Re: FirstLight Hydro Generating Company, Turners Falls Hydroelectric Project (FERC No. 1889) and Northfield Mountain Pumped Storage Project (FERC No. 2485).  
Response to Stakeholder Requests for Study Modifications and/or New Studies Based on the Study Report and Meeting Summary

FirstLight developed the attached responsiveness summary that addresses questions provided by stakeholders. It lists the stakeholder name, comment and FirstLight’s response. In some cases, additional information has been included in the form of Attachments. For study responses having more than one attachment, the labeling is as follows: Attachment A (Study 3.1.2), followed by Attachment B (Study 3.1.2) and so on. There are also Attachments for other studies, which are identified by the Study Number.

**Figure 4.2.3-1 Munn's Ferry Boat Camping Recreation Area Floating Boat Dock**

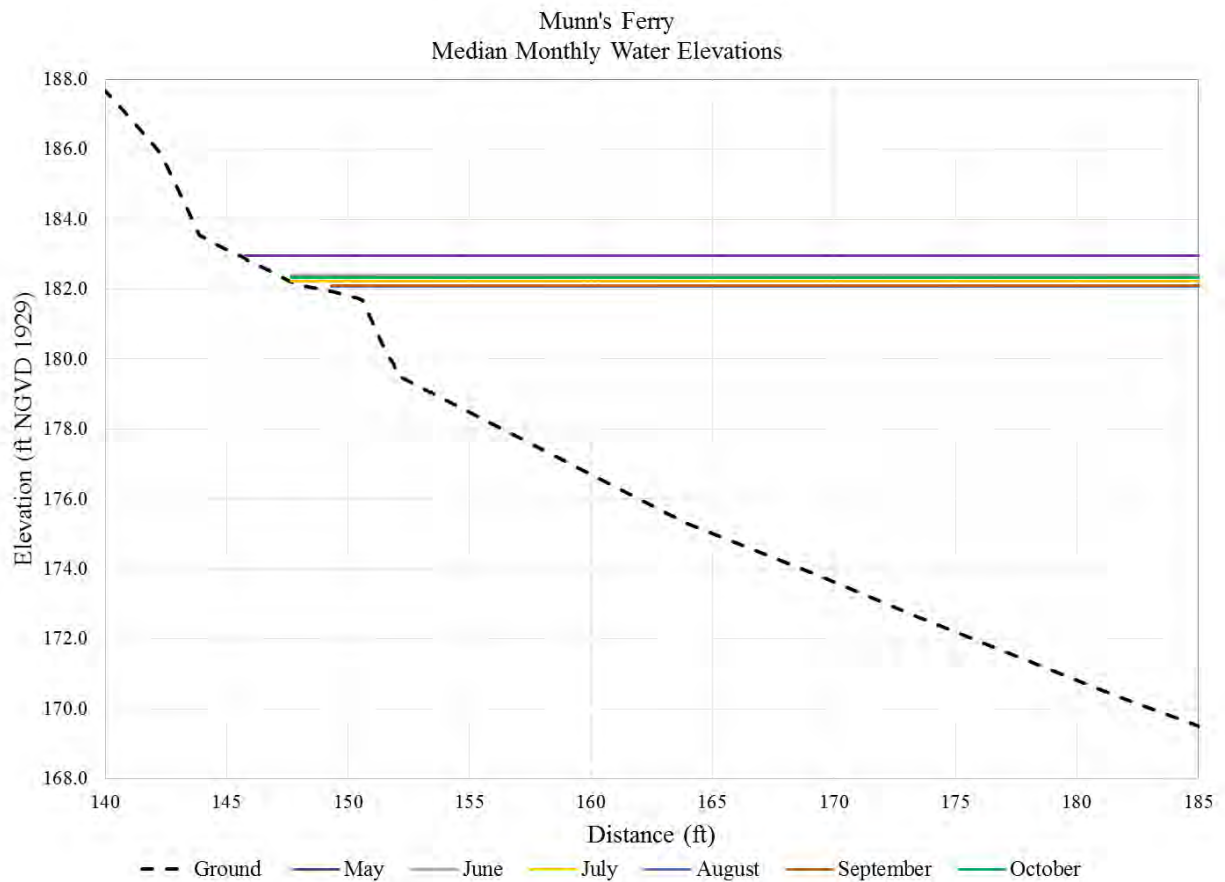
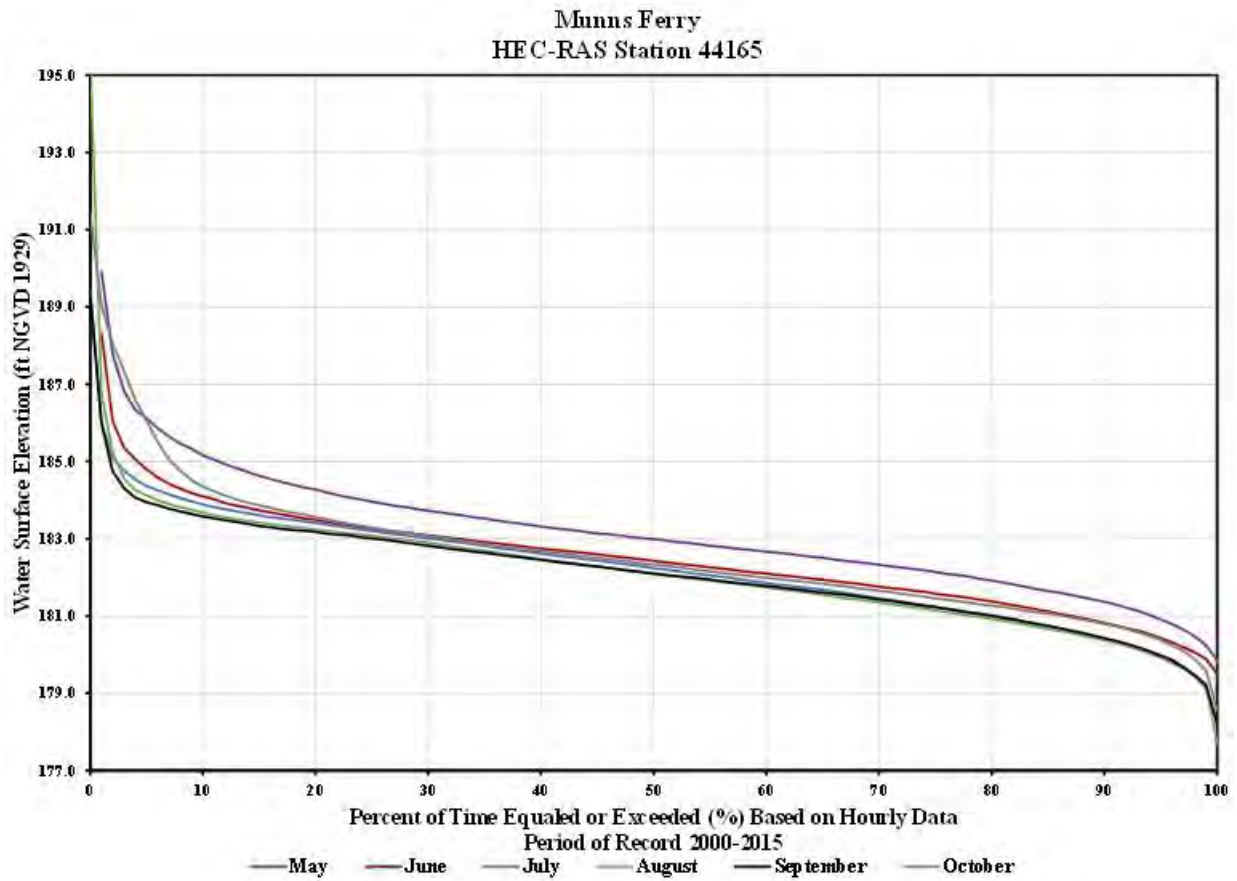
After filing the 3.6.6 Study Report, FirstLight found an error in the critical elevation reported for the floating boat dock associated with the Munn's Ferry Camping Recreation Area. The study report as filed with FERC on October 1, 2016 stated that the critical water surface elevation (WSEL) was 167'. That was an error. The actual critical elevation for the Munn's Ferry Boat Dock is 174'. Below is a revised Section 4.2.3 and [Table 5-1](#) of the study report for Study 3.6.6, which corrects the error. The overall result of the analysis for the Munn's Ferry Boat Dock remains unchanged i.e., the error in critical elevation did not change the outcome of the analysis. HEC-RAS modeling of historic conditions, shows that the elevation of the Turner's Falls Impoundment in the vicinity of the of Munn's Ferry never falls below elevation 174', so there is no impact on the Munn's Ferry Boat Dock associated with fluctuating water levels due to Project operations.
